TRAFFIC AND ACCESS REPORT  
FOR PROPOSED WAREHOUSE,  
DISTRIBUTION CENTRE AND  
OFFICE DEVELOPMENT,  
74 EDINBURGH ROAD,  
MARRICKVILLE

OCTOBER 2020  
(UPDATED JANUARY 2021)

Appendix E - Responses to submissions

PRELIMINARY PLAN

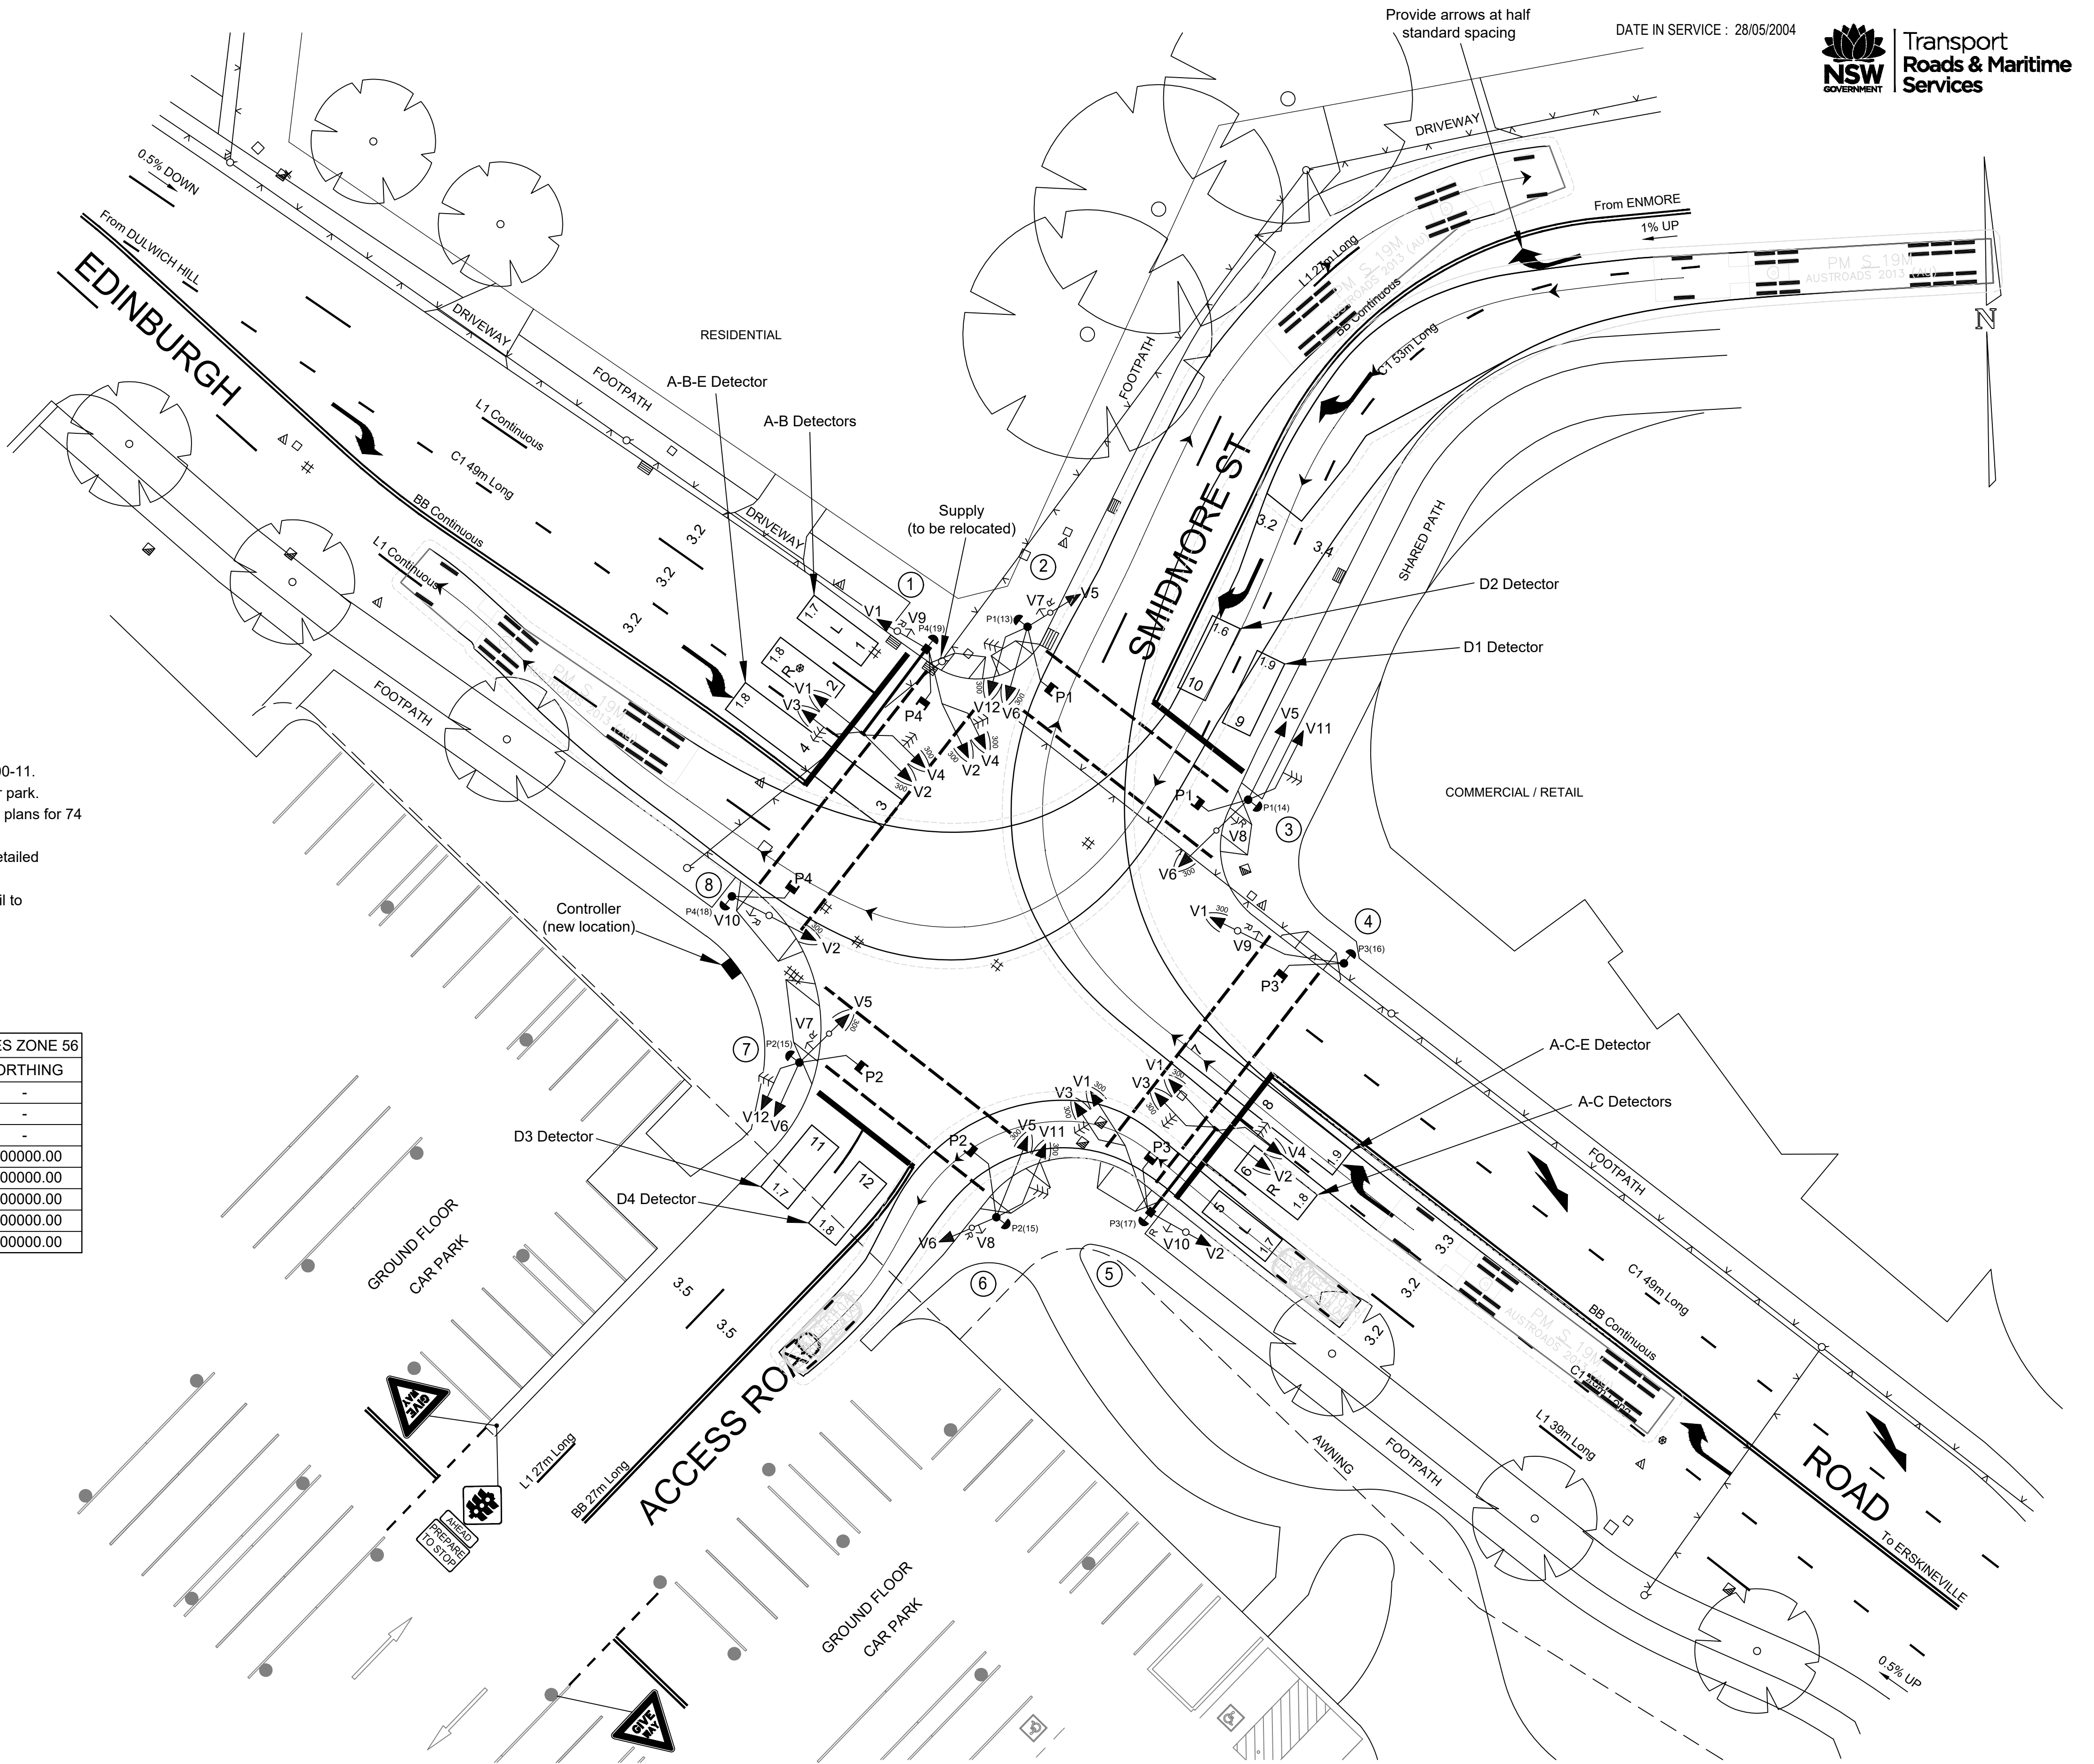
*A revised TIA, as part of the Response to Submissions (RtS), should be provided within inclusion of SIDRA modelling of the subject signalised intersection, specifically in relation to concerns regarding vehicle queuing along Edinburgh Road between Smidmore Street and Sydney Steel Road. The report should identify effects of the signal phasing and proposal signal capacity the aforementioned leg of the intersection up to the roundabout including operation in the analysis. An electronic copy of the findings should be submitted to TfNSW for review and verification as part of the RtS.*

7. It is expected that the intersection would operate with diamond phasing on Edinburgh Road and conventional phasing on the other approaches (Smidmore Street and the proposed site access), as shown on the draft signal plan provided in Appendix C of our previous report. However, we also note that signalised intersections are generally configured with the flexibility to operate in a variety of phases, depending on traffic demands.
